**PETITION NO:** Z-113  
**HEARING DATE (PC):** 12-06-16  
**HEARING DATE (BOC):** 12-20-16  
**PRESENT ZONING:** R-20

**APPLICANT:** Habitat for Humanity of Northwest Metro Atlanta, Inc. **PETITION NO.:** Z-113

**ZONING COMMENTS:** **Staff Member Responsible:** Jason A. Campbell

PROPOSED SUBDIVISION FOR:  
**Habitat for Humanity  
 NW Metro Atlanta**

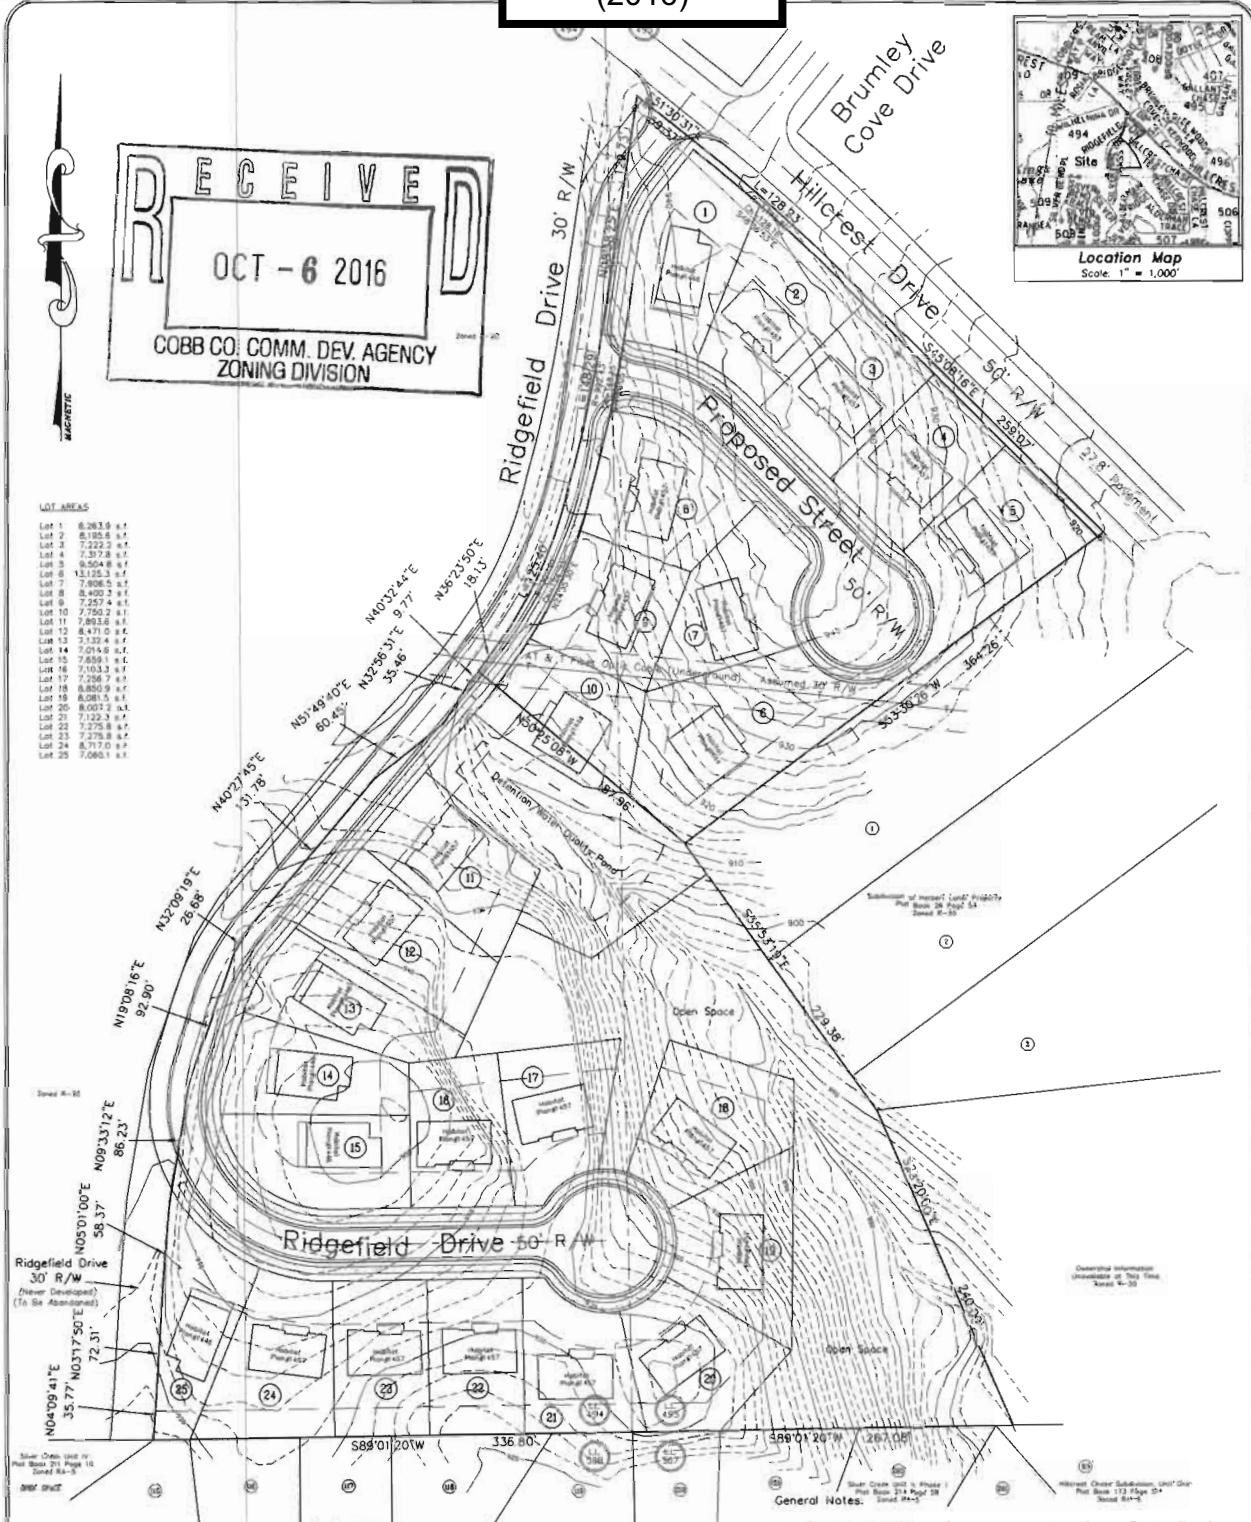
The proposed site plan will require a contemporaneous variance to waive the rear setback from the required 40 feet to 20 feet (the lots along Hillcrest Drive will continue to have a 40-foot rear setback).

Additional Sewer easement likely required to serve southern lots. Northern lots may be served via  
Comments: Hillcrest Drive, depending on final elevations

1. This site is located just south of Hillcrest Drive and east of Ridgefield Drive. The site is wooded with slopes ranging from approximately 5% near the ridgelines to 50% within the ravine that runs through the center of the site. The stream that traverses the site is identified on the County’s Stream Buffer Map as having a 50-foot undisturbed buffer. This will need to be verified since it will dictate the location of the proposed stormwater management facility. It will also impact the viability of lots 10, 11 & 18.

Hillcrest Drive is classified as a major collector and according to the available information the existing right-of-way does not meet the minimum requirements for this classification.

Ridgefield Drive is classified as a local and according to the available information the existing right-of-way does not meet the minimum requirements for this classification.

Recommend applicant consider entering into a development agreement pursuant to O.C.G.A. 36-71-13 for dedication of the following system improvements to mitigate traffic concerns: a) donation of right-of-way on the south side of Hillcrest Drive, a minimum of 40' from the roadway centerline.

Recommend applicant consider entering into a development agreement pursuant to O.C.G.A. 36-71-13 for dedication of the following system improvements to mitigate traffic concerns: a) donation of right-of-way on the east side of Ridgefield Drive, a minimum of 25' from the roadway centerline.

Recommend curb and gutter along both sides and sidewalk along one side of proposed development roadway.

Recommend curb, gutter, and sidewalk along the frontage of Ridgefield Drive and Hillcrest Drive.

Ridgefield Drive is a substandard street. Recommend improving Ridgefield Drive from along the frontage to the intersection with Hillcrest Drive to comply with Cobb County Standards.

Recommend a no access easement along the Hillcrest Drive frontage.

Recommend development street either directly align or have an offset of a minimum of 125 feet from Brumley Cove Drive per Development Standard 401.10.
